Product Change Notice (PCN)

PCN Number: PCN-0456242R-02

Product(s) Affected: *SJ1-353XNS Series (SJ1-3533NS, SJ1-3534NS, SJ1-3535NS)*

Description of Change: *Minor Layout and Material Difference. See image Below*

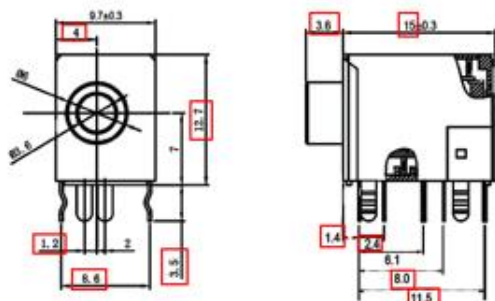
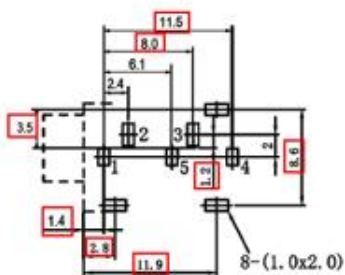
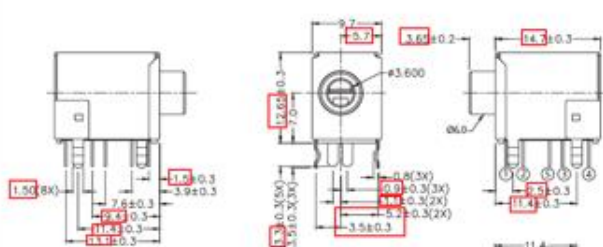
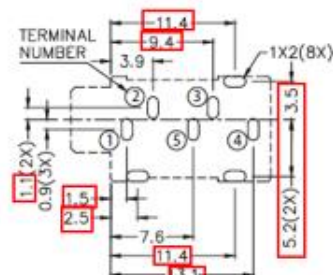
REV. 1.03

REV. 1.04

DESCRIPTION	MATERIAL	PLATING/COLOR
terminal 1	brass	silver
terminal 2	phosphor bronze	silver
terminal 3	phosphor bronze	silver
terminal 4	brass	silver
terminal 5	brass	silver
spring	stainless steel	nickel
bushing	brass H59	nickel
shield	SPCC t=0.30	nickel
housing	PBT (UL94V-0)	black

DESCRIPTION	MATERIAL	PLATING/COLOR
terminal 1	brass	tin
terminal 2	brass	tin
terminal 3	brass	tin
terminal 4	brass	tin
terminal 5	brass	tin
spring	stainless steel	
bushing	brass	nickel
shield	cold rolled steel	nickel
housing	PBT (UL94V-0)	black
